JEFFERSON CO. BLDG. DEPT
 PLAN APPROVED
 DATE 7-2-97 BY BJ

Garage Addition Details	Garage with optional door location. Furgun Hooks only
Scale 1/4" = 1'-0"	10-28-93
David Hoffman 742 N. 5. Cedar St. Madison, OR 97741

SECTION "S-S" 1/4" = 1'-0"

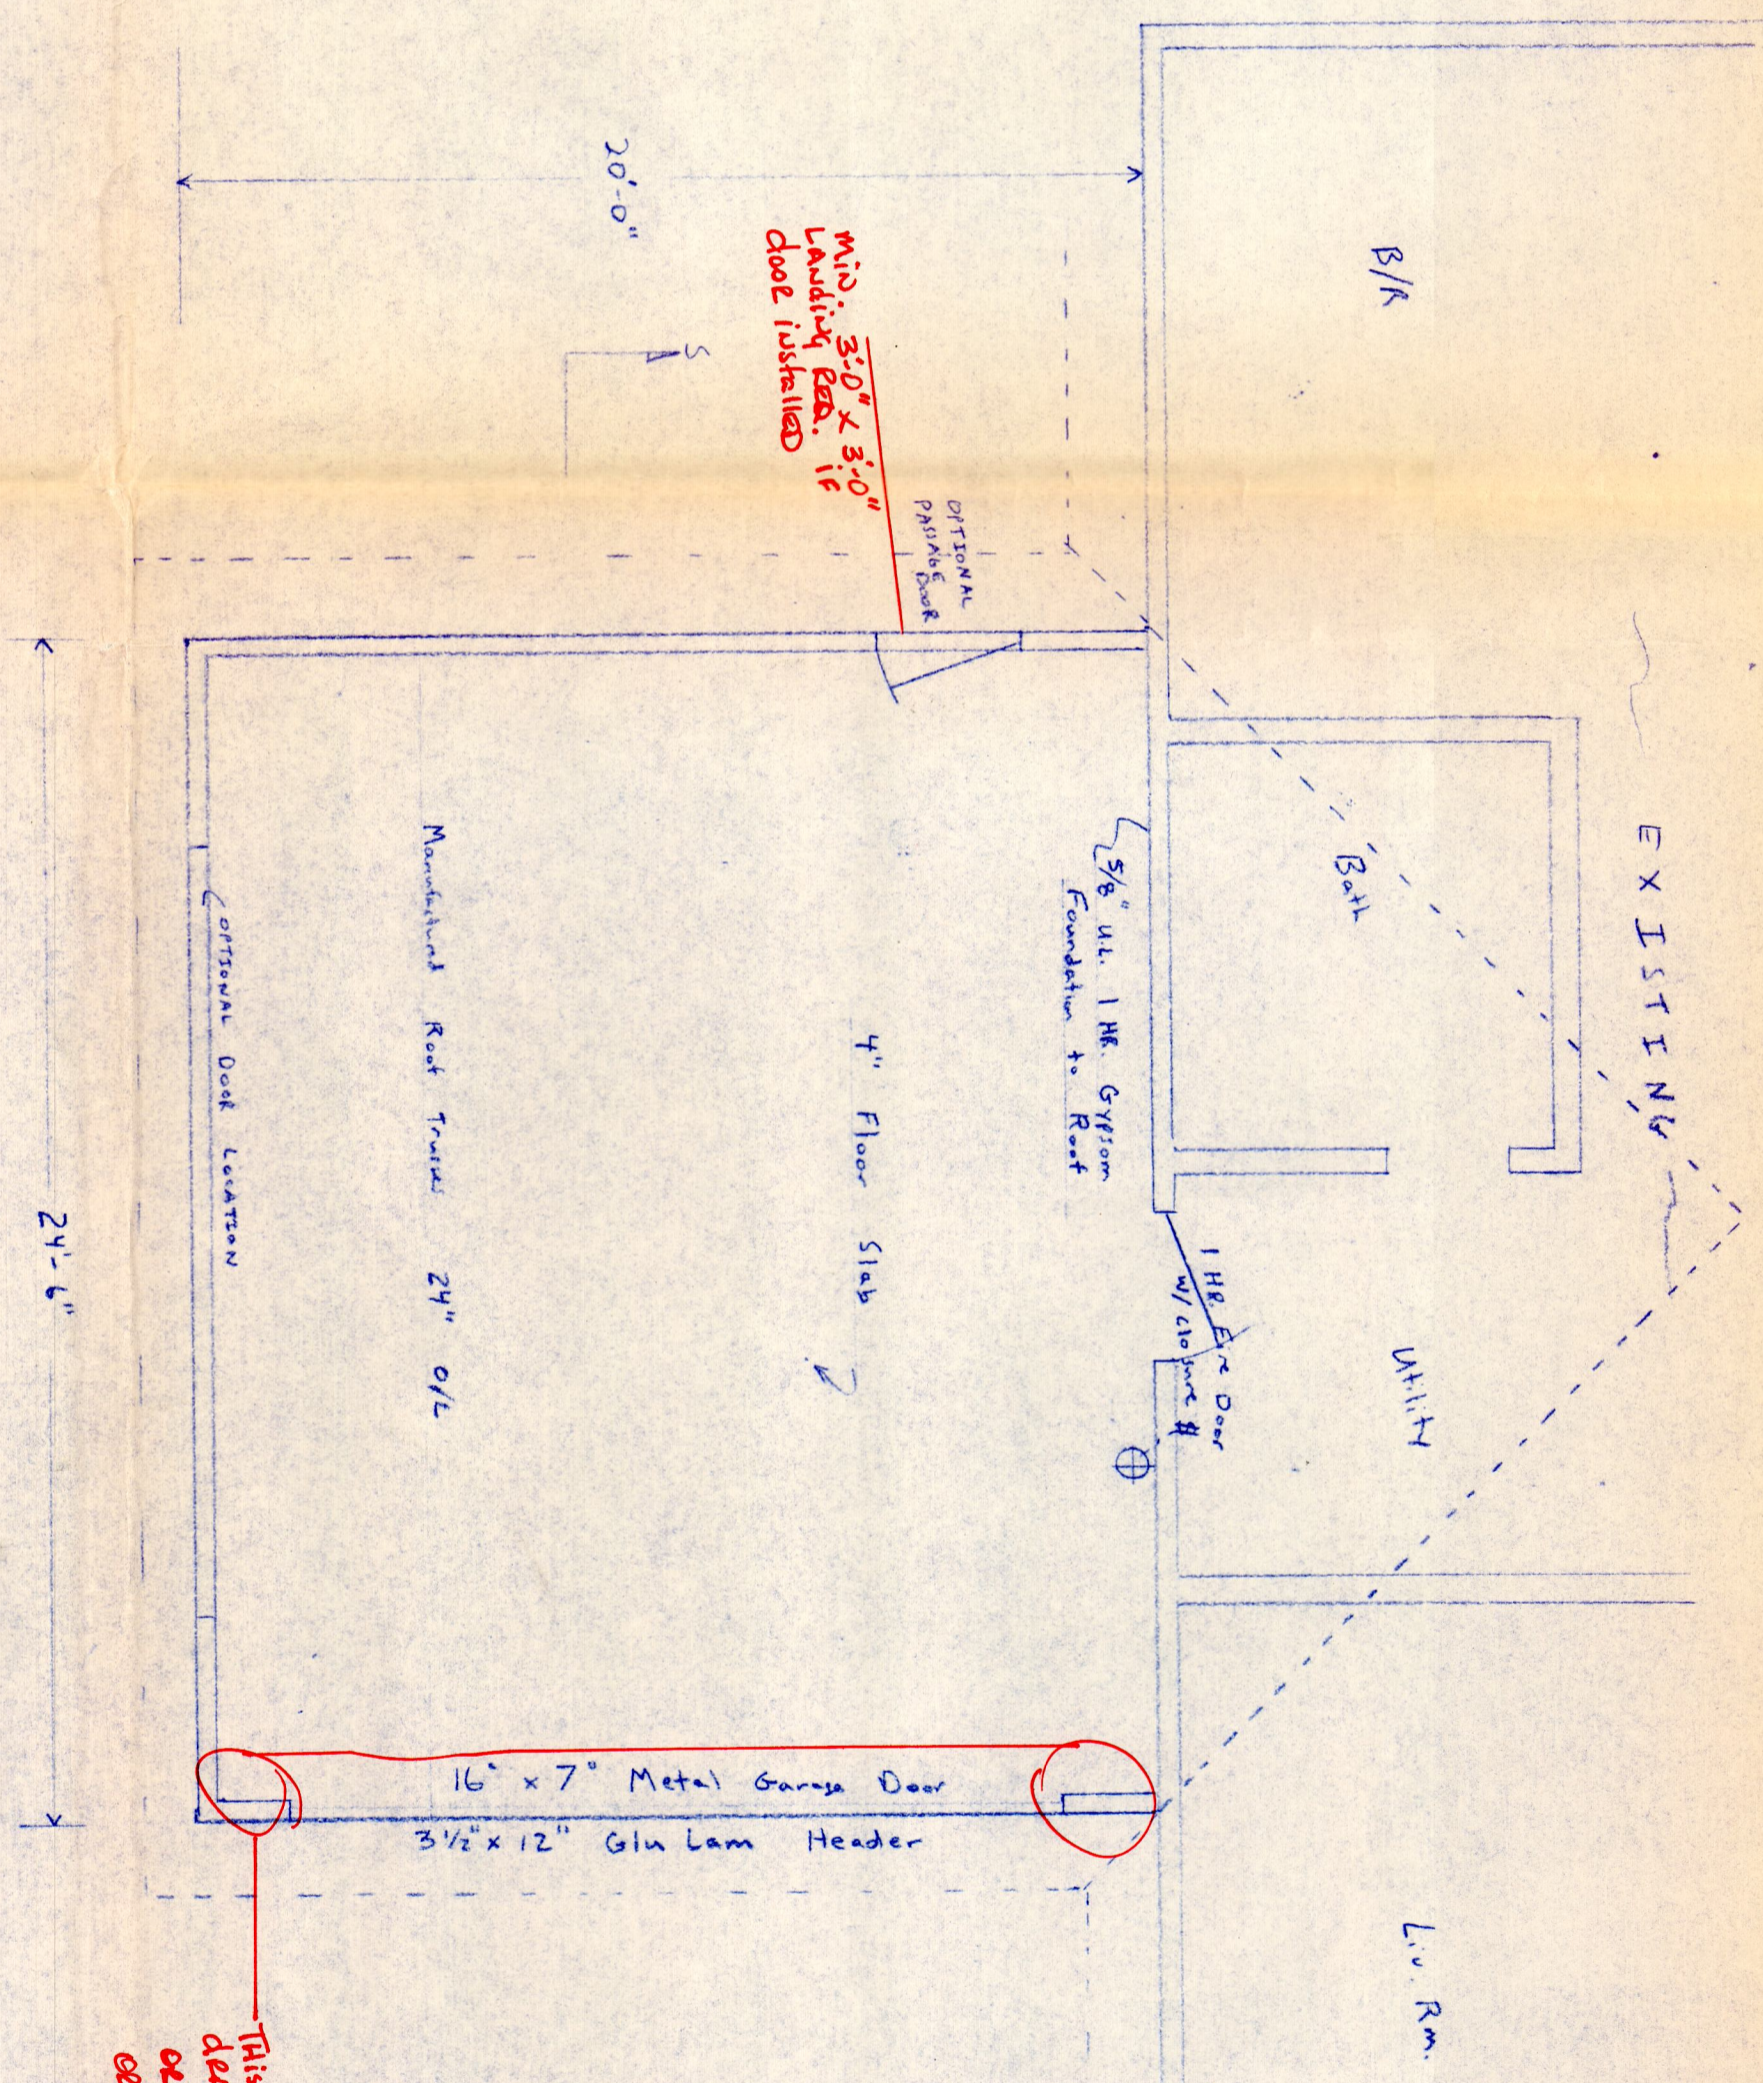
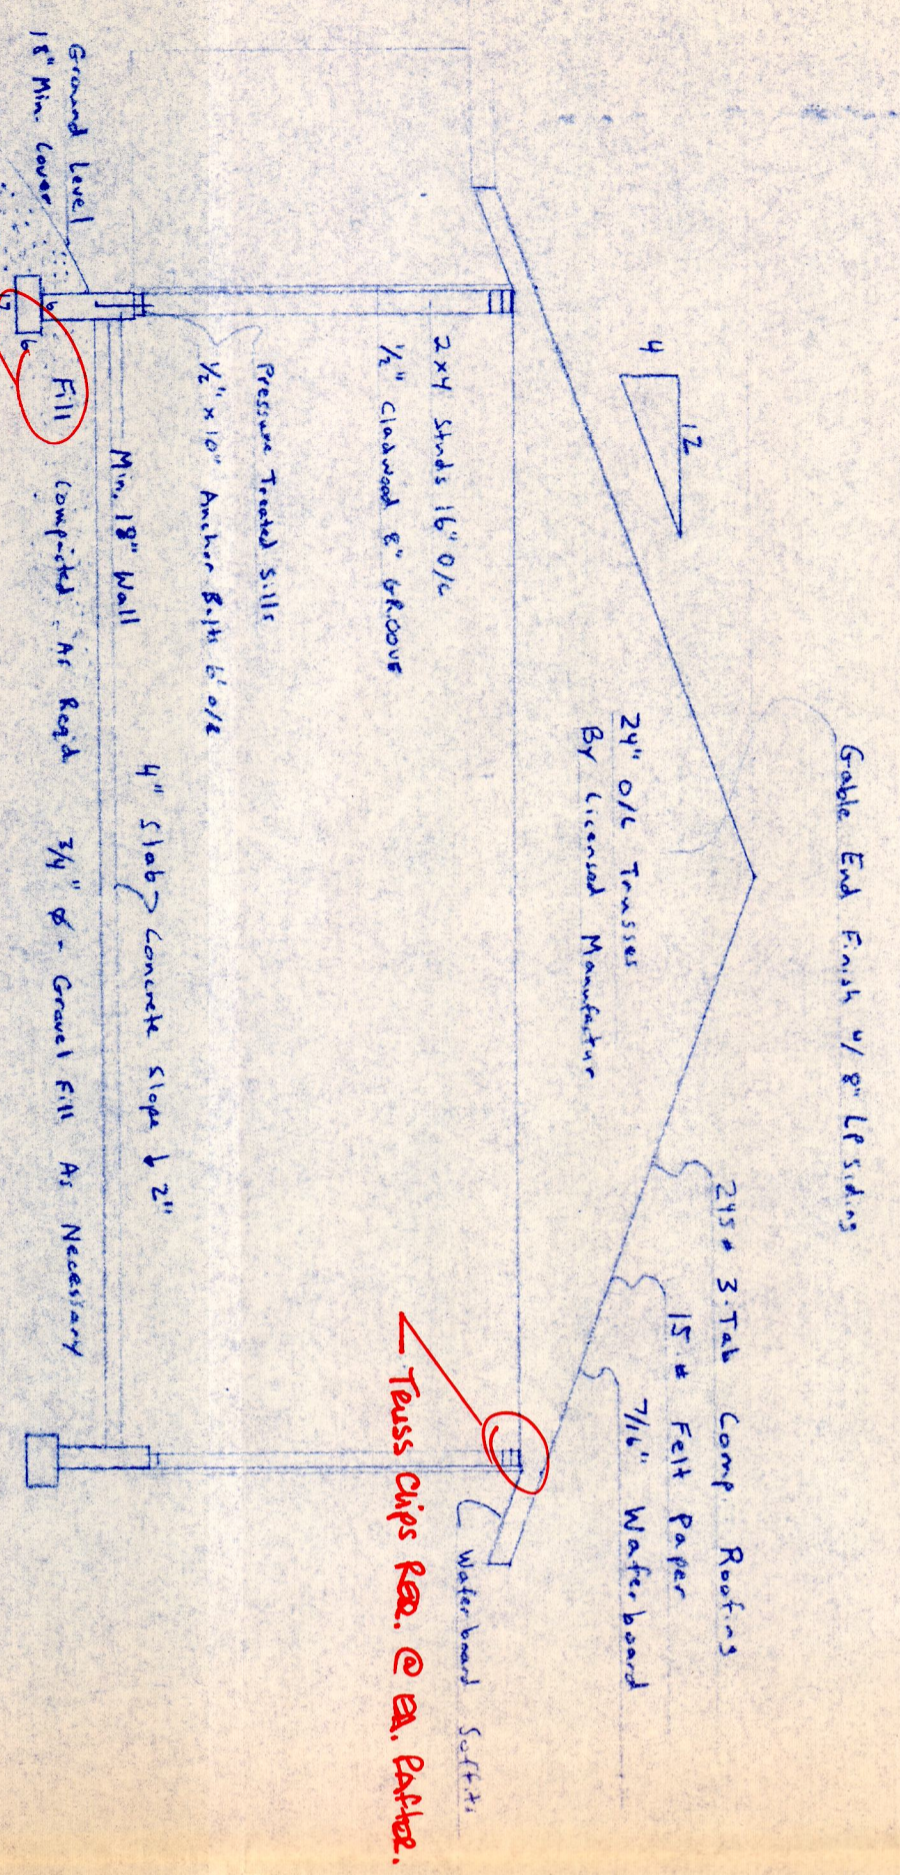
Footings must be on undisturbed soil or compacted test bed.

This wall must be built to be attached to existing; or provide 4' proud (min) on ext. side; or provide engineering
